RE: Response to Technical Notice of Deficiency #2 – Permit Renewal
RCRA Permit Renewal Application, Ascend Performance Materials Texas Inc.,
Alvin, Texas, Hazardous Waste Permit No. 50189, SWR No. 30138
EPA Identification No. TXD001700806
RN100238682/ CN60348281
Tracking No. 30019169

Hazardous Waste Permit Renewal Application
Ascend Performance Materials Texas Inc., Alvin, Texas

Response to TCEQ Technical NOD#2

**Attachment 1 – Comment Response
Summary Table**

Figure V.11.3  
Ascend Performance Materials Texas Inc., Alvin, Texas  
Hazardous Waste Permit No. 50189

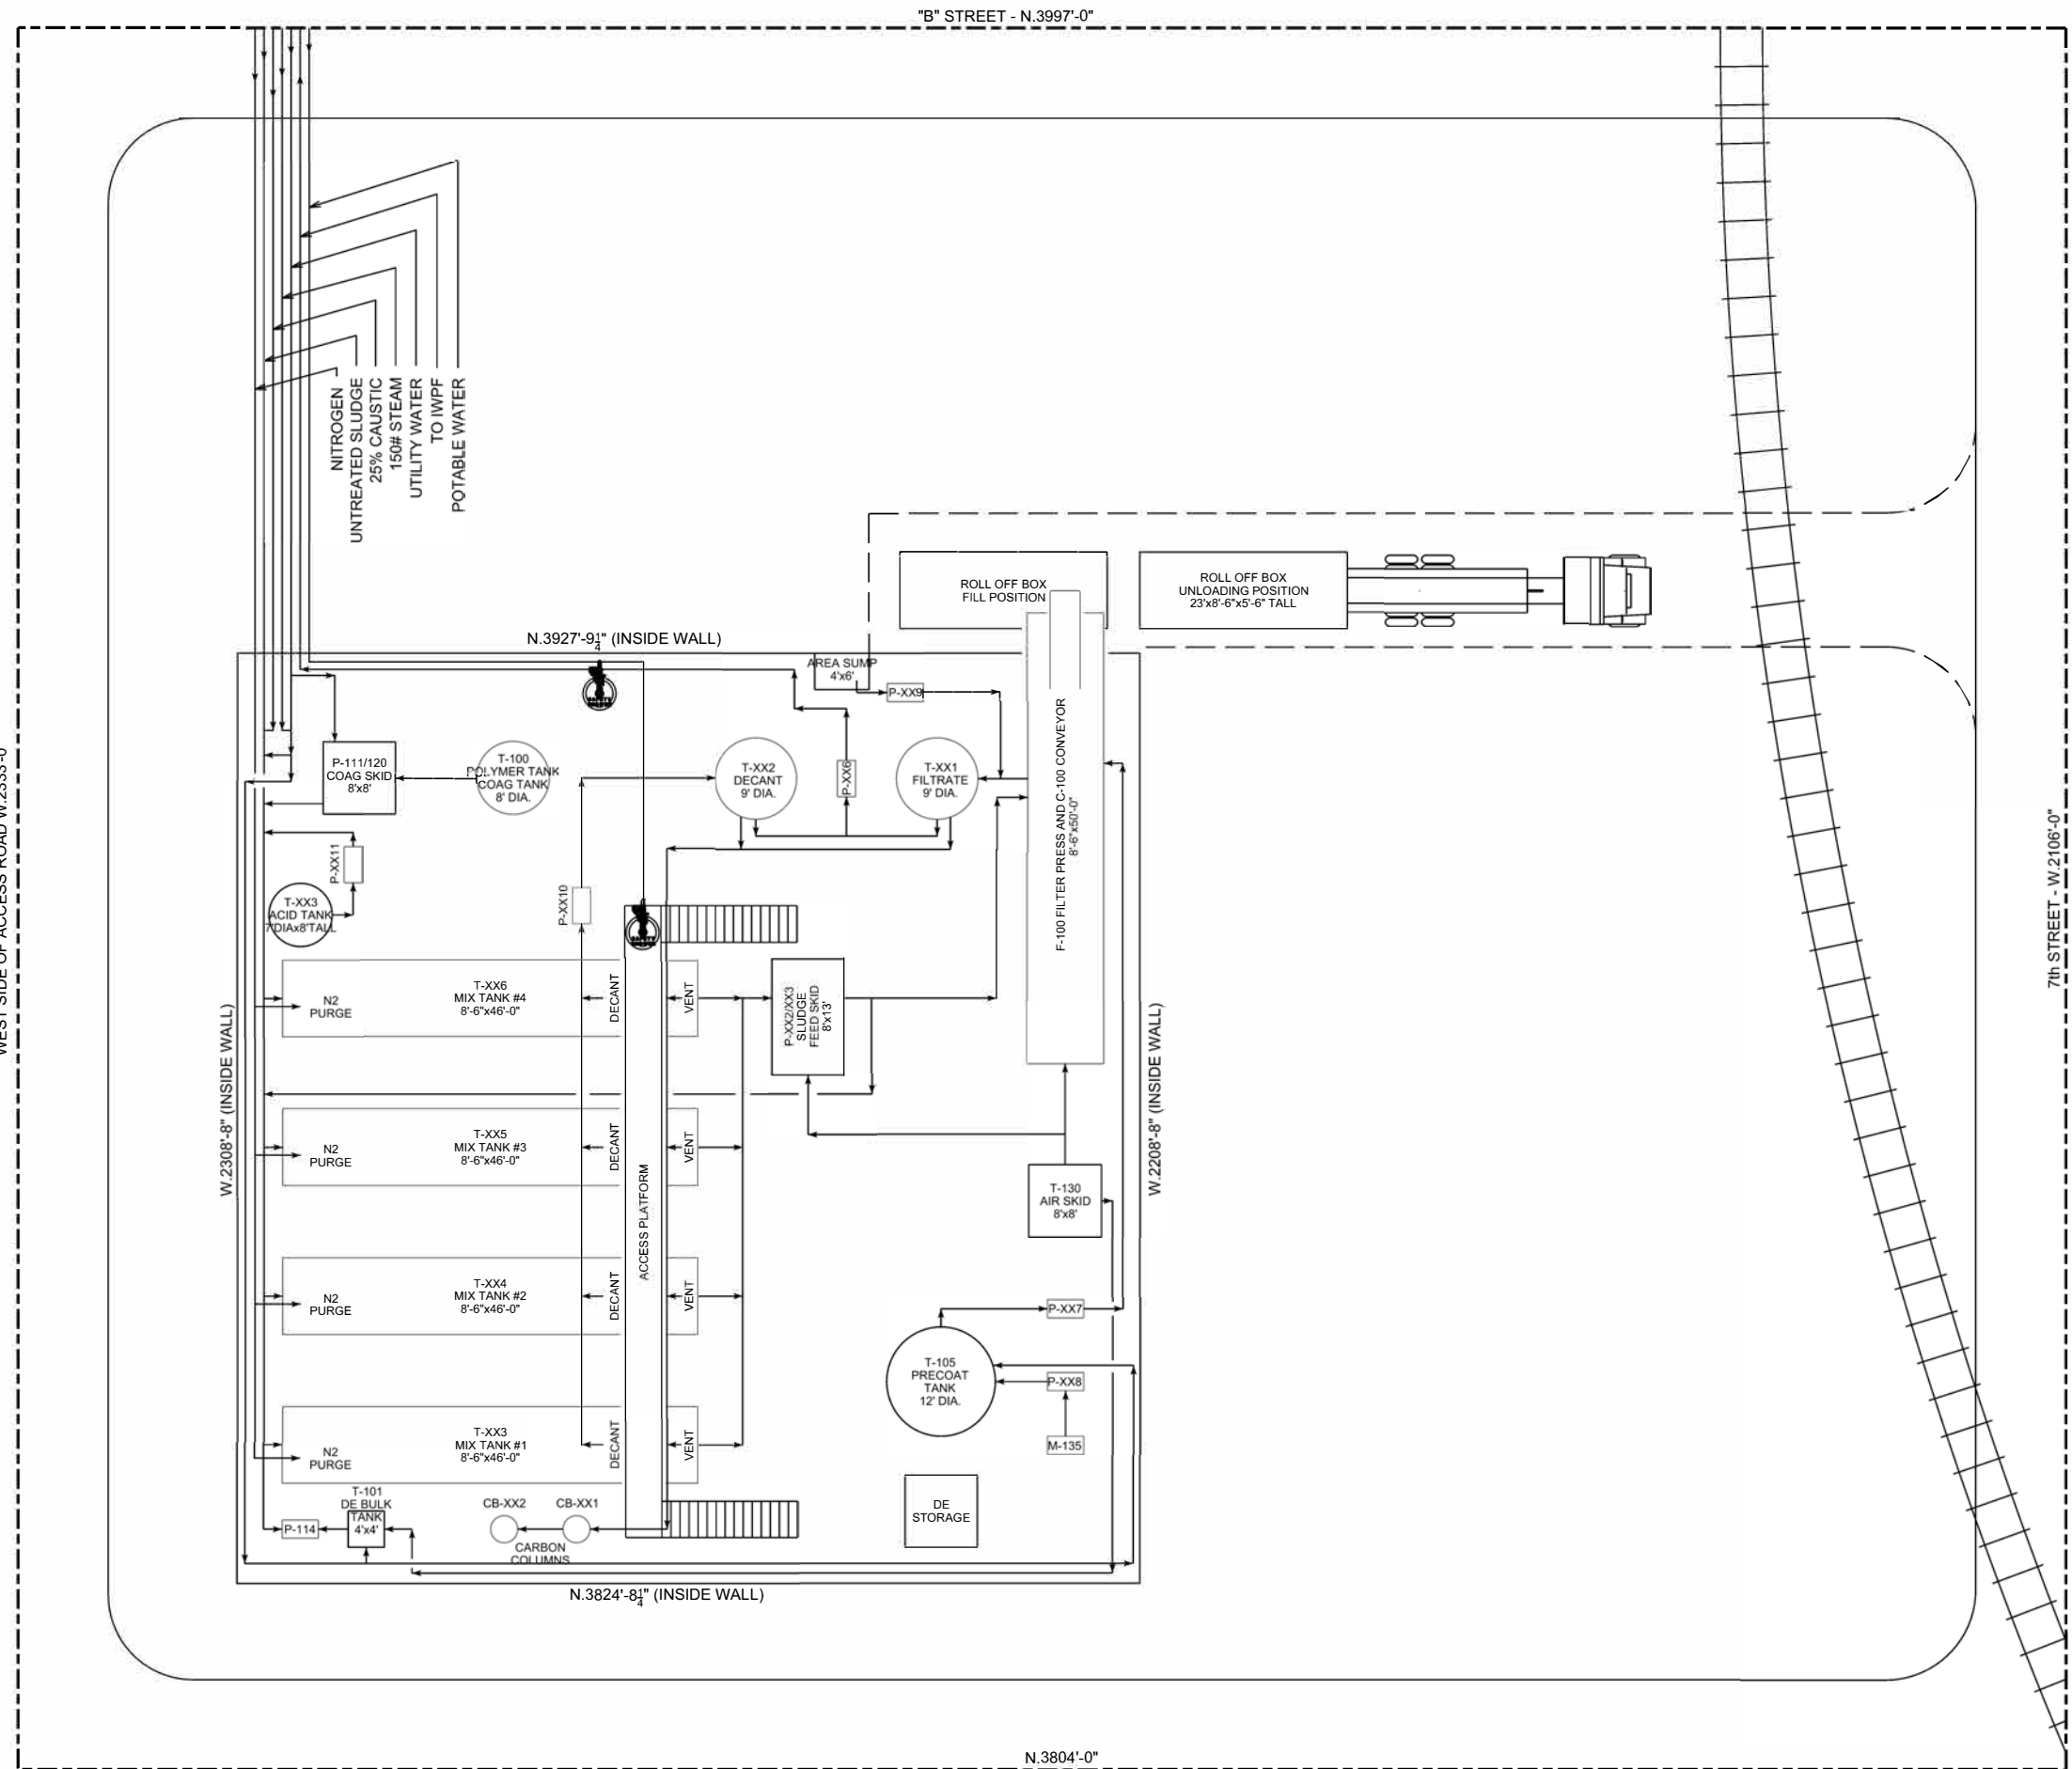
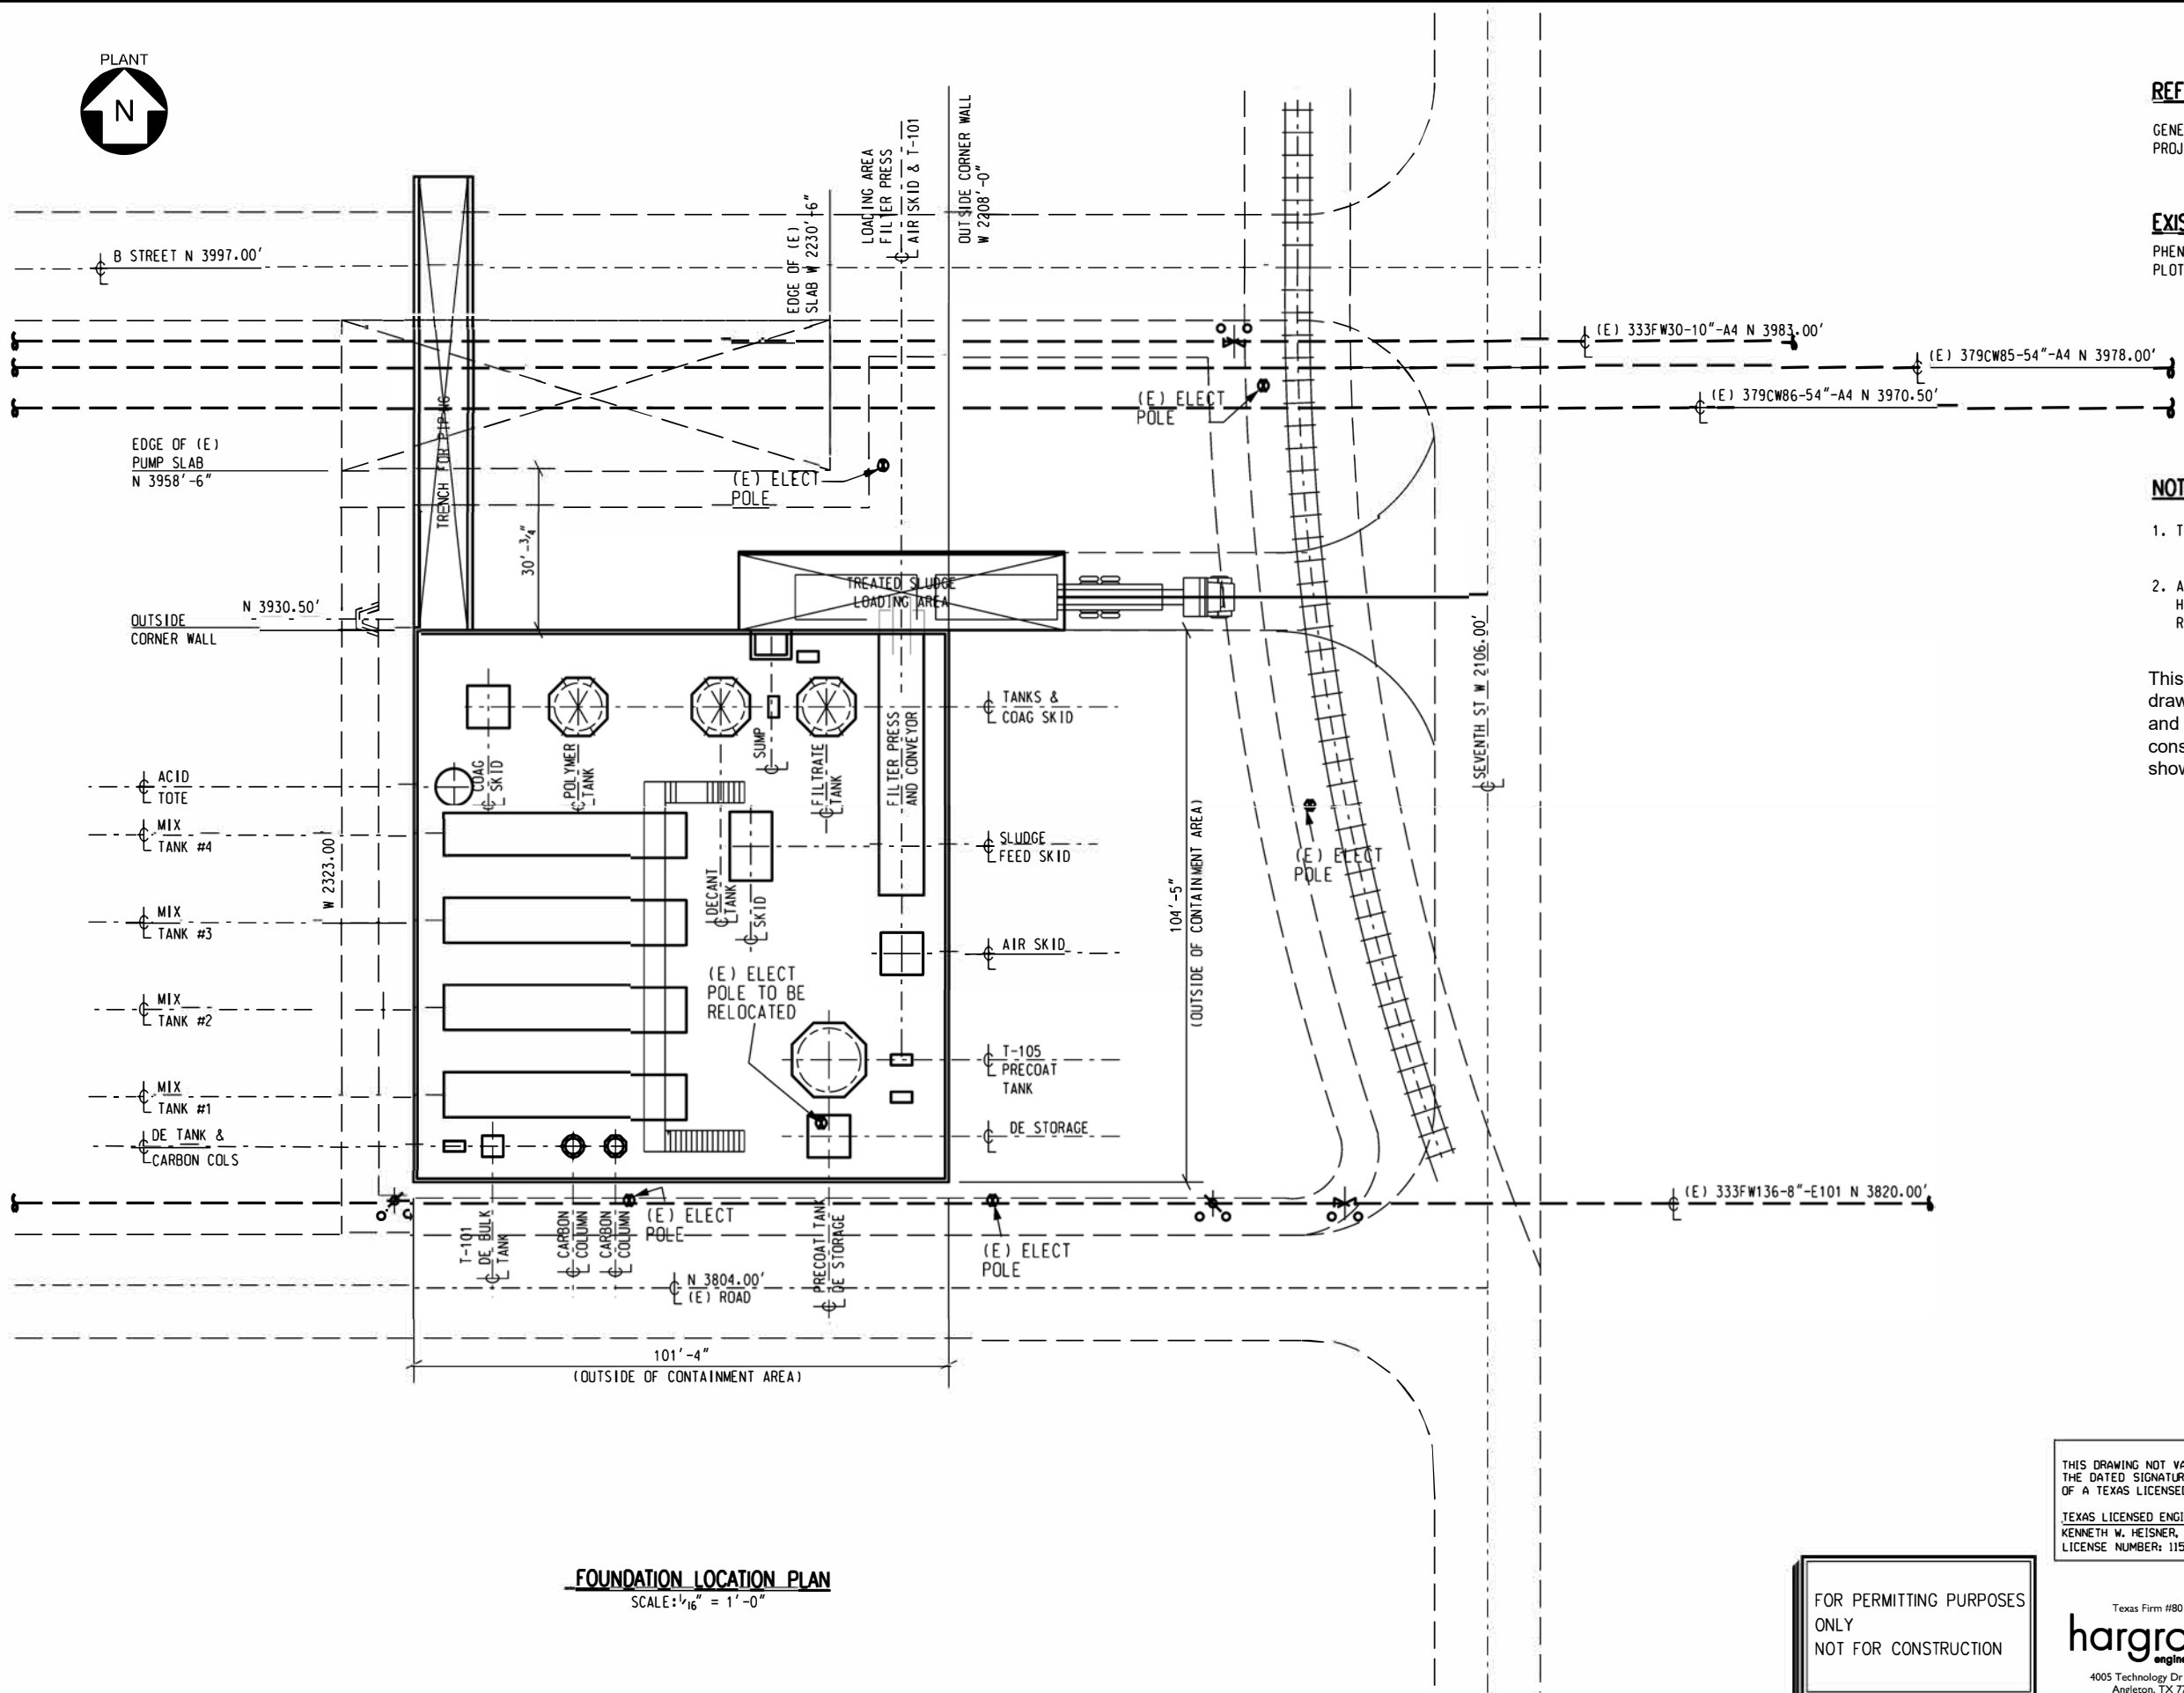
ID ¹	App. Part	App. Section	Location ²	Citation	Error Type ³	TCEQ Deficiency Description/Resolution	Ascend Response
T17 from NOD1	B	V	Appendix V.C.1 – Engineering Report for IWPF Tanks <i>(note this should refer to Appendix V.C.2)</i>	270.14; 305.50(a)(7)	Incomplete	Provide a Professional Engineer (P.E.) seal, signature and date for the remaining Figures V.11.3 and V.11.4. Indicate the Figure sub-number for drawing Figure V.11.1.	<p>Ascend cannot provide P.E.-seals on Figures V.11.3 and V.11.4 referenced in Comment T17 in Technical NOD #1. As noted in Ascend's response to the Technical NOD #1, Figures V.11.3 and V.11.4 could not be sealed, because these were the pre-construction design drawings that showed separate decant and filtrate tanks for the Solids Handling Unit. As noted previously, the decant and filtrate tanks were combined into one single wastewater tank during construction. This is shown on the P.E.-sealed Process Flow Diagram (PFD; pg. 656 of Volume 2 of the original permit application) that was provided in response to Comment T21 of Technical NOD #1.</p> <p>For the permit renewal application, the PFD that was provided in response to T21 of Technical NOD #1 can also be used as Figure V.11.1, replacing pg. 625 of Volume 2 of the original permit application. Attached is the sealed PFD labeled as Figure V.11.1. In addition, a note has been added to Figures V.11.3 and V.11.4 to indicate that the drawings show separate decant and filtrate tanks. However, the unit was constructed combining both tanks as shown in Figure V.11.1.</p>

This drawing is a pre-construction drawing and shows separate decant and filtrate tanks. However, the unit was constructed combining both tanks as shown in Figure V.11.1.

This drawing is a pre-construction drawing and shows separate decant and filtrate tanks. However, the unit was constructed combining both tanks as shown in Figure V.11.1.
